**STAFFORDSHIRE MOORLANDS DISTRICT COUNCIL  
PLANNING APPLICATIONS COMMITTEE**

**24 June 2021**

Application No:	SMD/2021/0235	
Location	Rose Cottage, Back Lane, Heaton, Staffs, SK11 0SJ	
Proposal	Roof terrace	
Applicant	Mrs J Taylor	
Agent	Sammons Architectural Ltd	
Parish/ward	Heaton. Dane Ward	Date registered: 30 <sup>th</sup> March 2021
If you have a question about this report please contact: Chris Johnston email: Christopher.johnston@staffsmoorlands.gov.uk

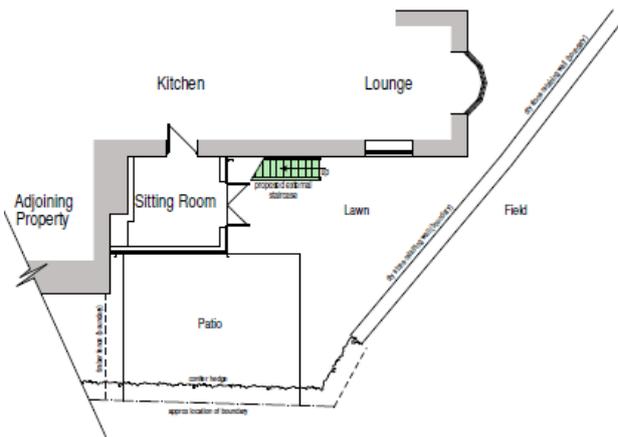
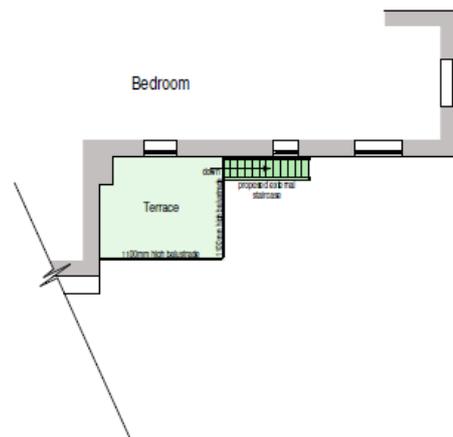
7.5 It is considered that the proposed balustrading on top of the flat roof would not harm the appearance of the traditional stone cottage as it would be placed on top of a flat-roofed rear extension of modern form and would have an appropriate black metal finish and design. However, it is considered the proposed metal external staircase, due to its scale, form and siting against the traditional rear main stone wall of the cottage would be out of keeping with its traditional appearance. Therefore the proposal is considered to be unsympathetic to the traditional stone cottage and would not harmonise with it and therefore does not respect the site or its surrounding and therefore would not comply with Policy DC1 in this respect.

7.7 When stood on the flat roof of the rear extension which is proposed to become a roof terrace, it is possible to look over the hedge on the rear boundary of the site, which is the side boundary of the rear garden of Heaton Bank and a large amount of the rear garden of Heaton Bank, which is a minimum of just 4.5 metres from the back edge of the flat roof, is easily visible from the roof of the extension. The parts of the garden that are visible are clearly used by the occupants of Heaton Bank for their outdoor enjoyment judging from the presence of a mowed lawn, outdoor seating and a greenhouse. Although it is difficult to view the rear elevation of the dwelling at Heaton Bank and the garden area adjacent to the rear wall due to the presence of a tree and higher boundary hedge closer to the house, due to the extent of overlooking, amounting to over half of the rear garden, it is considered this would lead to a significant level of harm to the privacy of the occupants of Heaton Bank.

7.9 From the top of the roof of the rear extension at Rose Cottage, it is also possible to view into a rear paved patio area at ground floor level at Ivy Cottage, the attached residential property to the north. It is considered that the scope of overlooking into the ground level patio area of Ivy Cottage from the raised platform where the proposed balcony would be placed, would also cause significant harm to the residential amenities of Ivy Cottage both due to the level of overlooking and the perception of being overlooked. Although there is also a roof terrace at Ivy Cottage, this is set away from the shared side boundary behind the stone two-storey rear outrigger at Ivy Cottage which forms a high wall on the side edge of the proposed balcony. As a result there is no harmful scope of overlooking from the terrace at Ivy Cottage into the rear garden of Rose Cottage. As the proposed balcony at Rose Cottage would be adjacent to the shared side boundary and not set back from it, the scope of overlooking from the proposed balcony into Ivy Cottage and its rear patio is greater, despite the presence of the rear outrigger, because the proposed rear edge of the flat roof is almost level with the back wall of the outrigger so when stood

further along the back edge of the proposed balcony, away from the side boundary and outrigger, a greater amount of overlooking into the Ivy Cottage property is possible.

**1. The proposed raised roof terrace/balcony, due to its height above ground and siting, would lead to a significant degree of overlooking into the private outdoor amenity areas of two adjacent residential properties, Heaton Bank, to the west of the site and Ivy Cottage, to the north of the site, leading to an intrusive and unneighbourly form of development affecting the levels of privacy enjoyed at those properties and leading to significant harm to the overall residential amenities of both properties. The application therefore does not comply with Policy DC1 'Design Considerations' of the Council's Local Plan (adopted September 2020) or Section 12 of the National Planning Policy Framework (NPPF) which seek to protect, inter alia, the residential amenities of the area from new development.**

**2. The proposed external staircase, by virtue of its form, scale, design and siting would harm the appearance of the traditional stone cottage it would be placed against and therefore would not comply with Policy DC1 'Design Considerations' of the Council's Local Plan (adopted September 2020) or Section 12 of the National Planning Policy Framework (NPPF) which seek to protect, inter alia, the visual amenities of the area from new development.**
